ADDENDUM NO. FOUR

PROJECT: Johnson County Recycling Center

PROJECT NUMBER: 23122

DATE OF ADDENDUM: June 5, 2024

GRADING PLAN
JOHNSON COUNTY RECYCLE CENTER

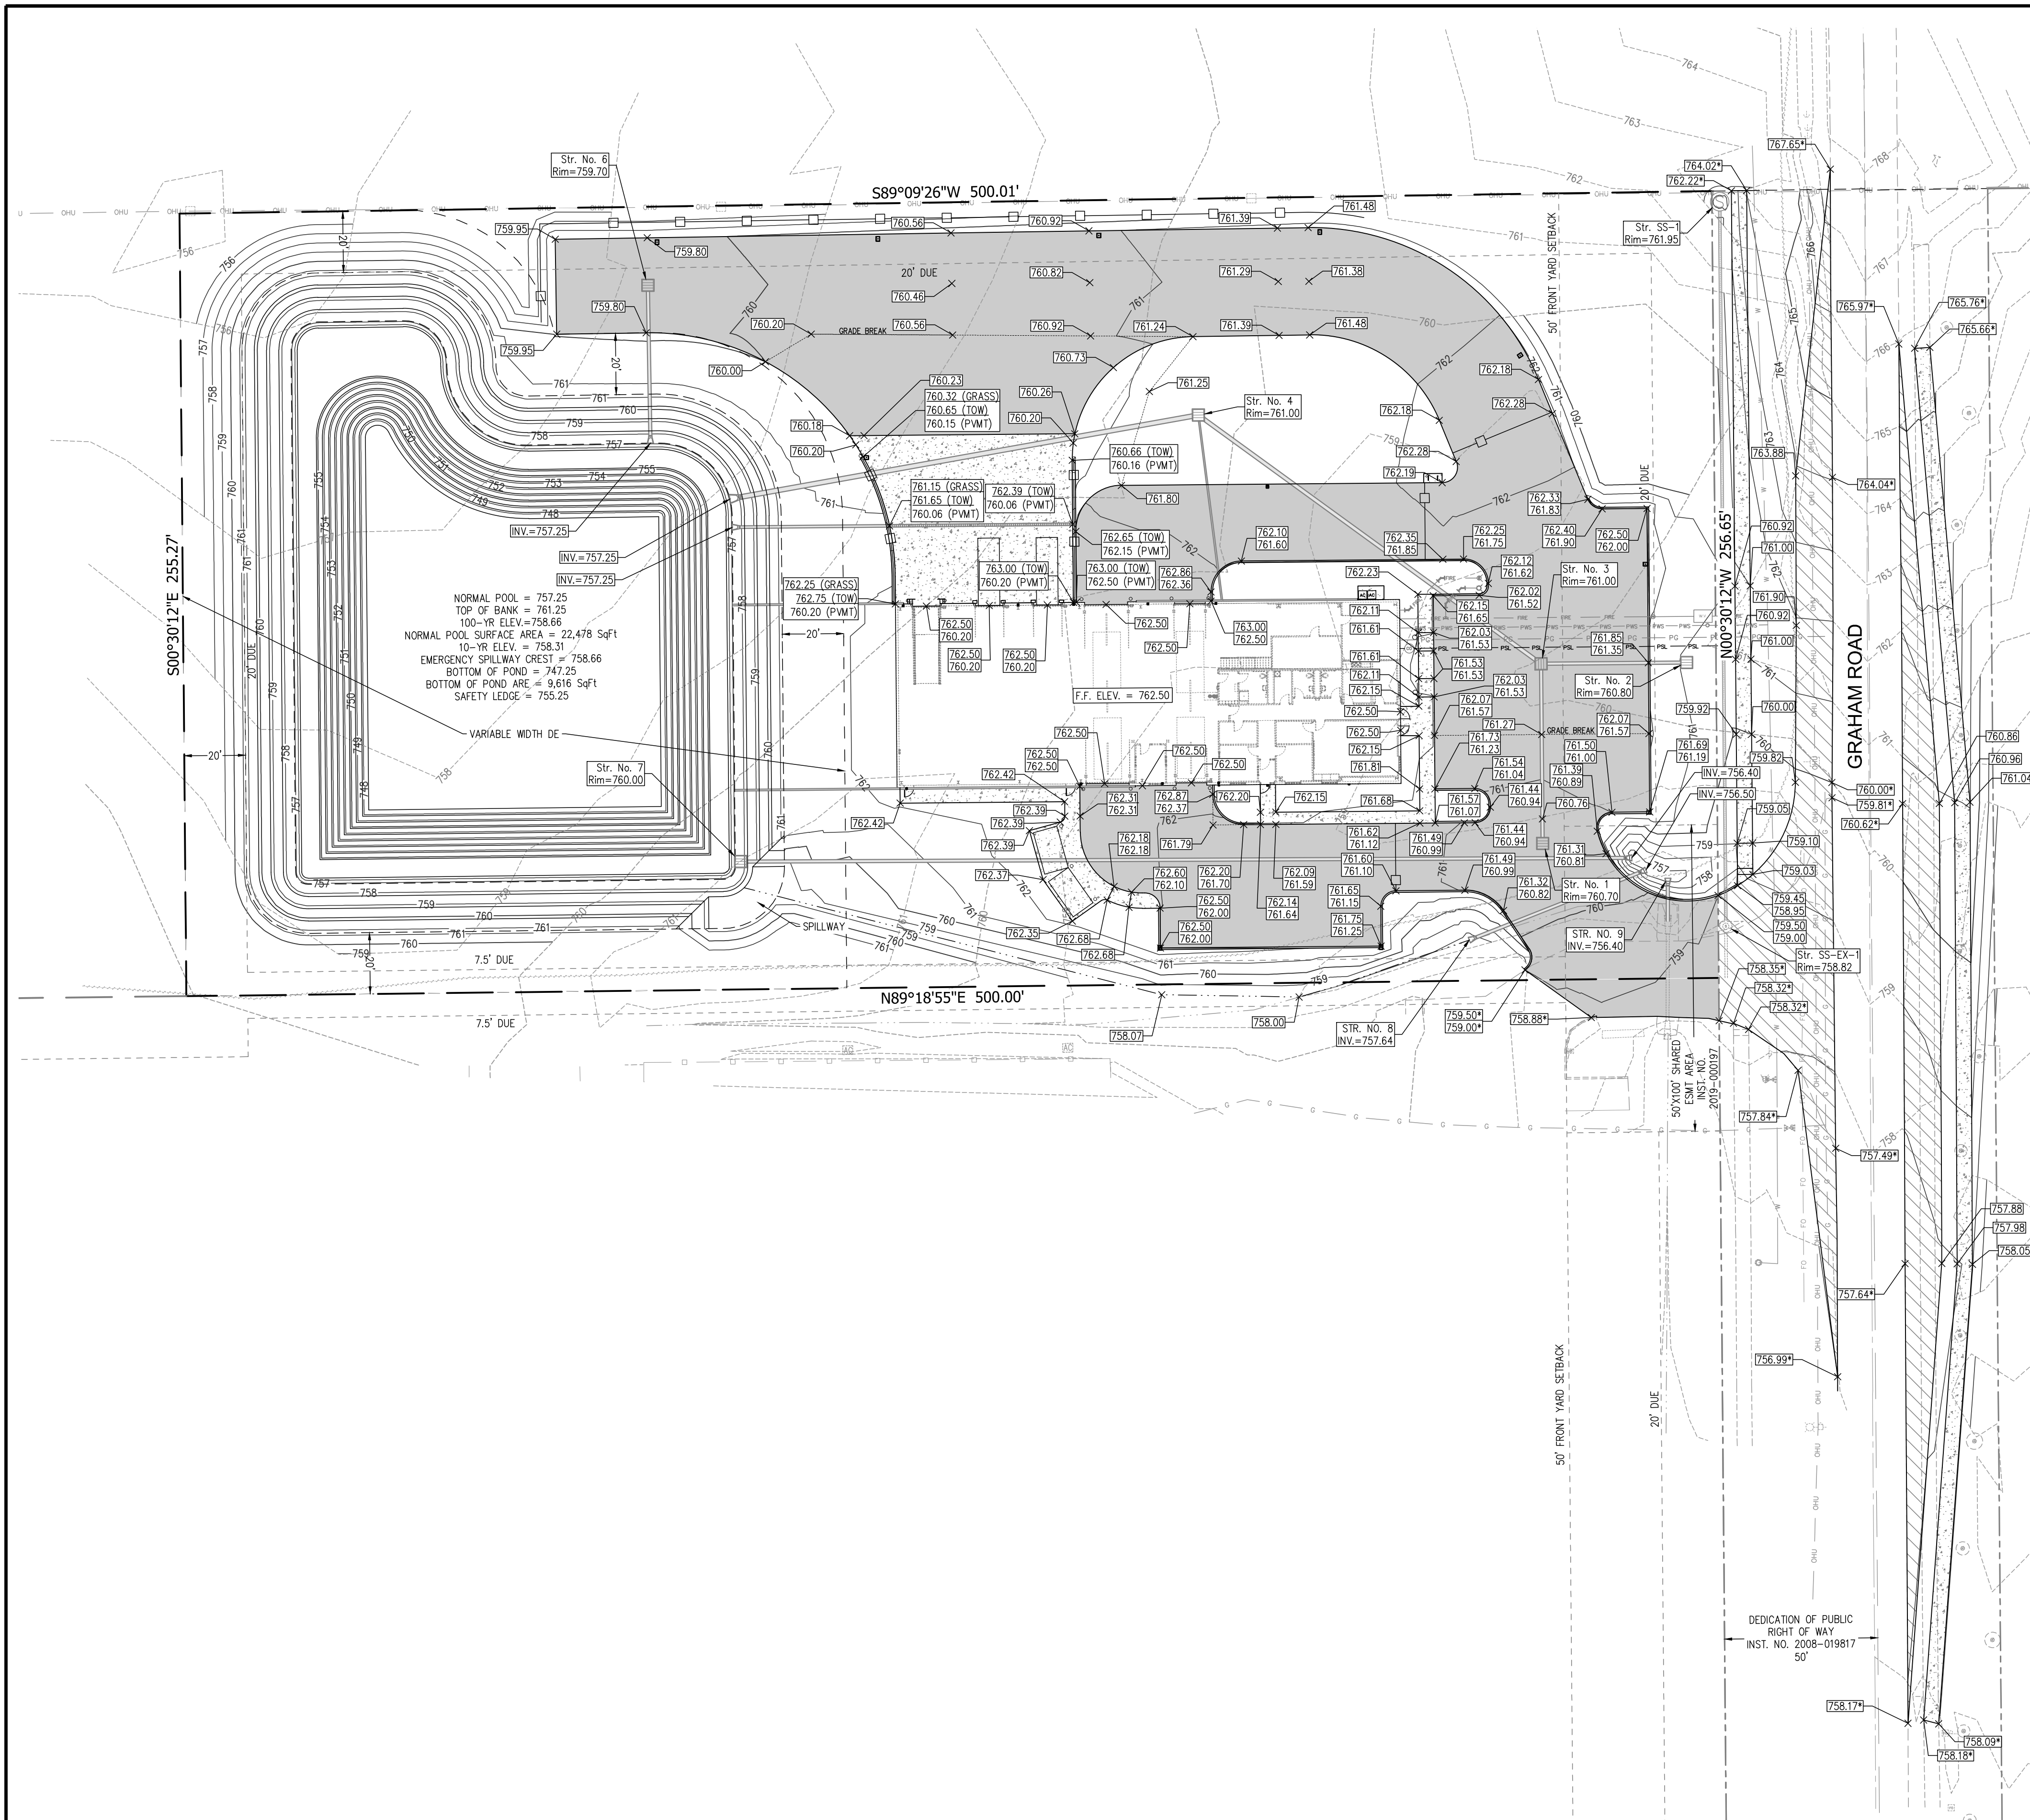
- Sheet 500
 - o Added ditch from pond spillway to existing ditch south of building
 - o Adjusted grades around additional Tox Box
 - o Adjusted grades at sidewalk along edge of pavement south of the building

SANITARY PLAN AND PROFILE

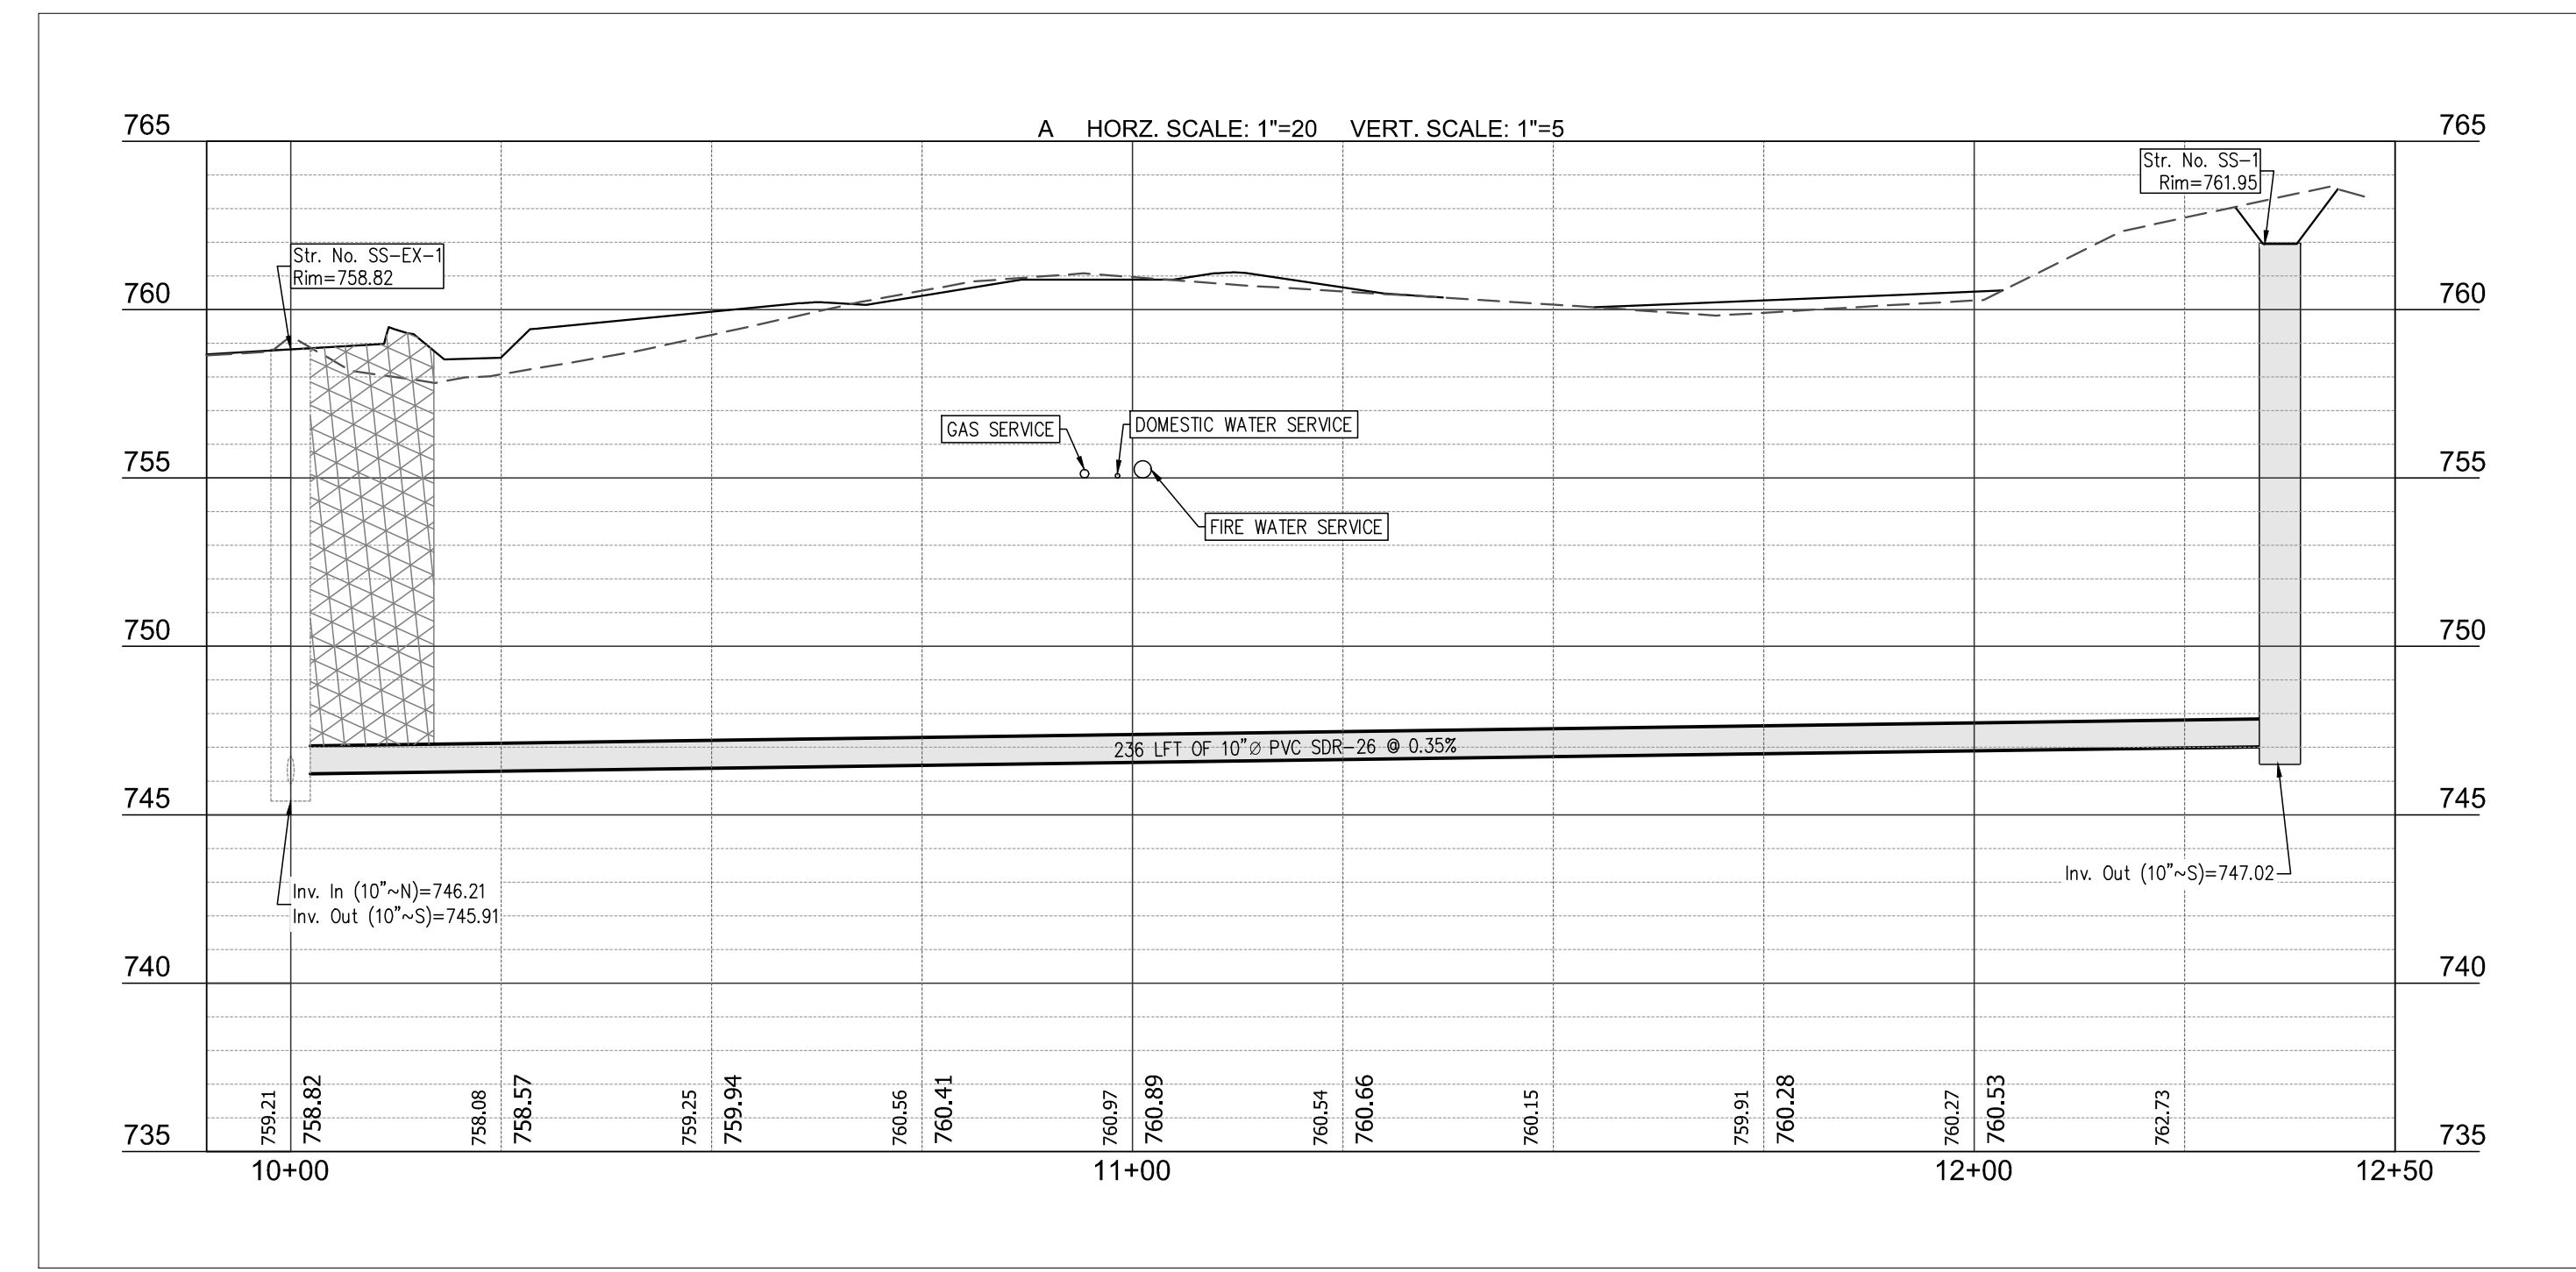
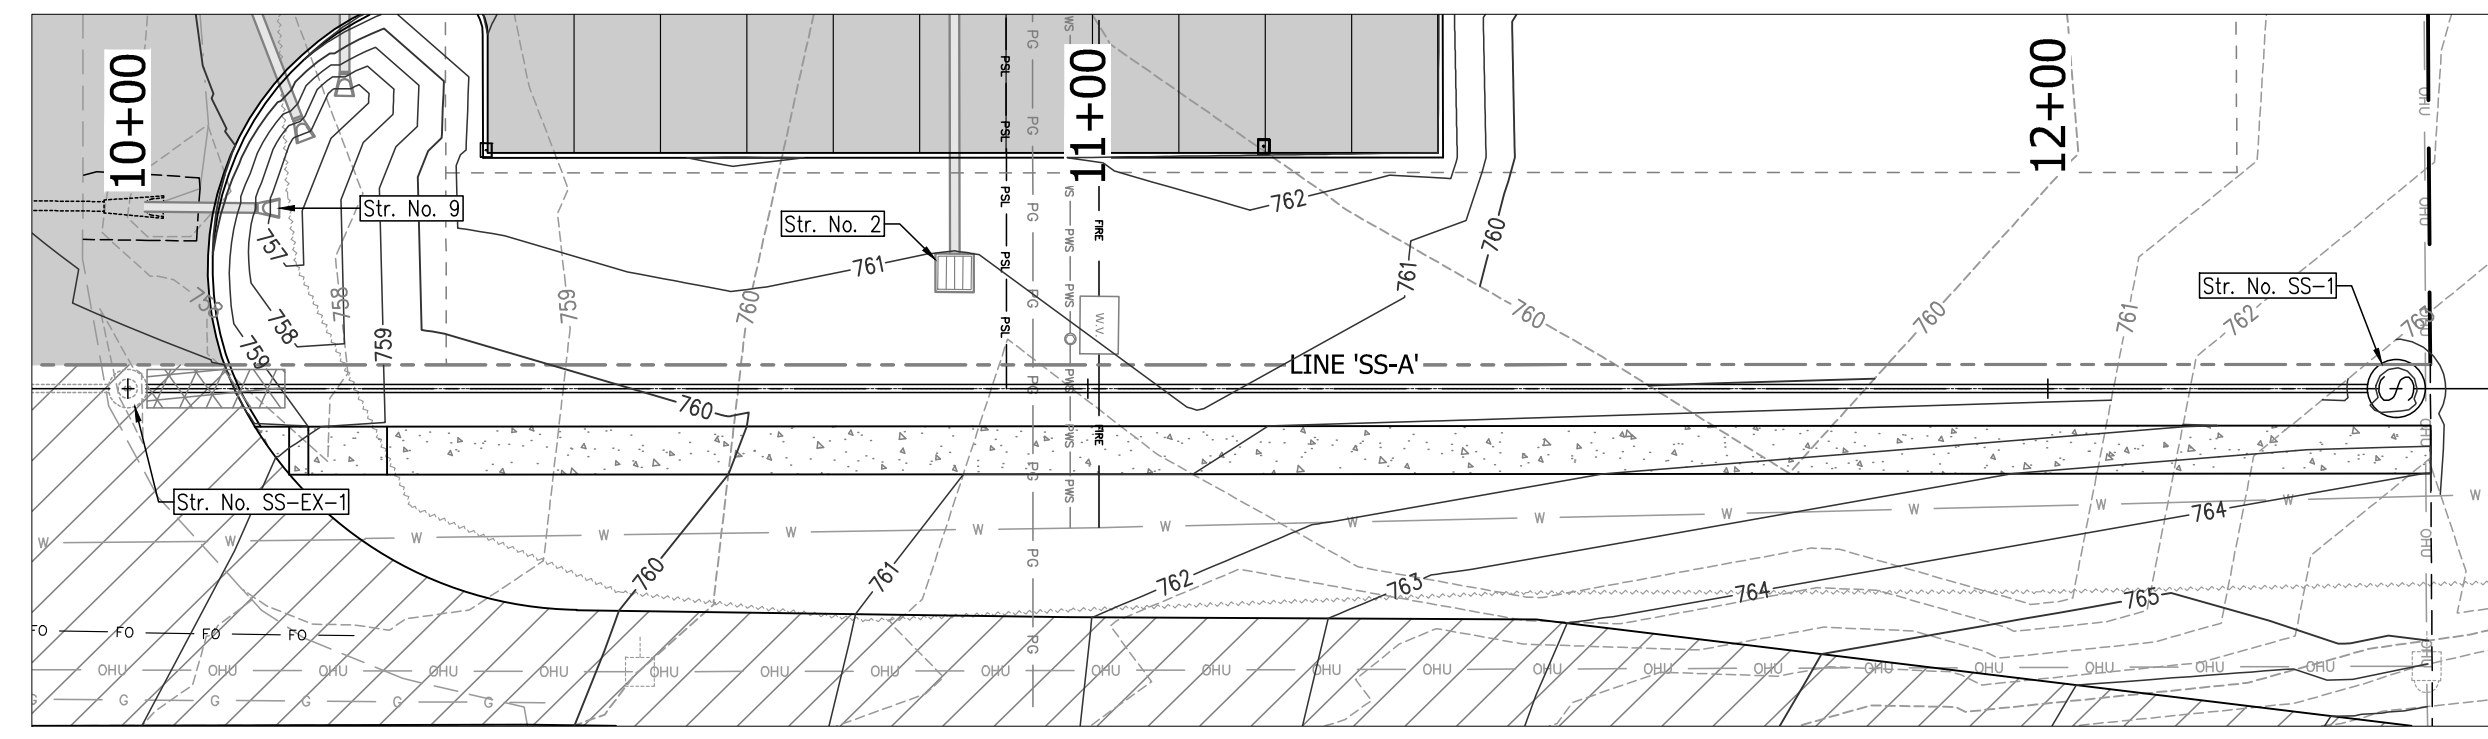
- Sheet 800
 - o Added Utility Crossings for Line 'SS-A'
 - o Changed the pipe type to be SDR-26 instead of SDR-35
 - o Added Sanitary Main Installation Notes
